Rainbow Aircraft (Pty) Ltd

SERVICE BULLETIN

IMPORTANCE	High
AREA AFFECTED	Nose gear
SB SERIAL NUMBER	Cheetah/004/222011

SUBJECT: Nose gear hairline cracks

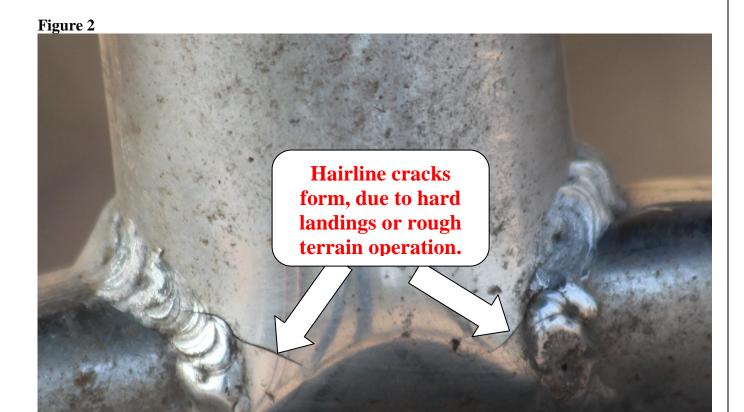
The operator reported two small hairline cracks forming in the area where the strut is welded to the fork. see figure 1

- 1) Remove the front fork Spat (if installed)
- 2) Clean the affected area in order to better the inspection
- 3) Utilising a bright light, inspect the indicated area see figure 2
- 4) If no cracks were found assemble the removed parts
- 5) Continue further operation
- 6) Inspect every 50 normal landings (with Spats)
- 7) Inspect every time with hard landings (with Spats)
- 8) Include this inspection in your pre-flight if no spats are fitted. This is normally the case with aircraft being utilized as per point 1b

If cracks are found, do not continue operation, contact the factory with immediate effect. Parts or repairs will be discussed.
